UNITED STATES
NUCLEAR REGULATORY COMMISSION
WASHINGTON, D.C. 20555-0001

LICENSEE: Exelon Generation Company, LLC
FACILITY: Three Mile Island Nuclear Station, Unit 1
SUBJECT: PUBLIC MEETING WITH THE U.S. NUCLEAR REGULATORY COMMISSION
AND EXELON GENERATION COMPANY, LLC REGARDING GENERIC
LETTER 2004-02 (TAC NO. MC4724)

GL 2004-02 CLOSE OUT
FOR
THREE MILE ISLAND
UNIT 1

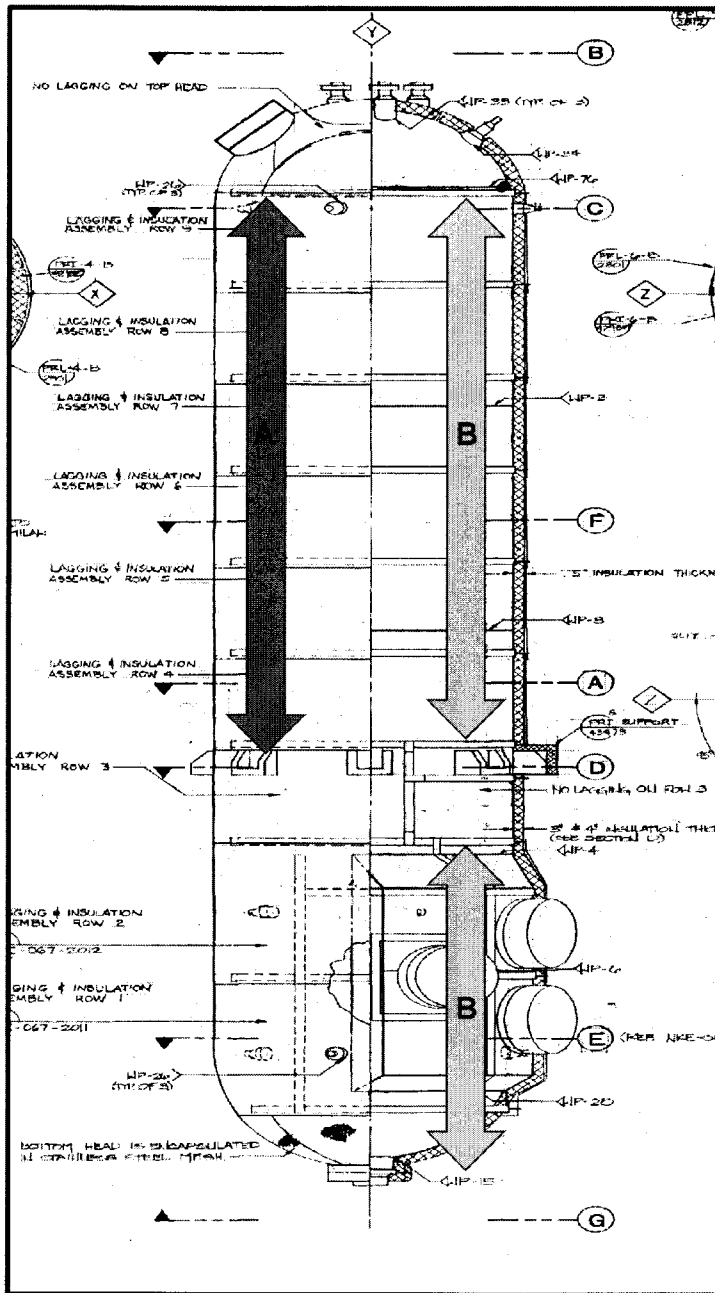
TMI pressurizer is currently insulated entirely with Nukon blanket insulation. Two options for replacing Nukon with MRI will be investigated:

Option A: replace Nukon insulation above the support region with the exception of the upper head.

Option B: replace Nukon insulation in all locations except upper head and inside the support.

The head loss test sequence will determine which option will result in acceptable NPSH for the ECCS pumps and acceptable maximum strainer DP.
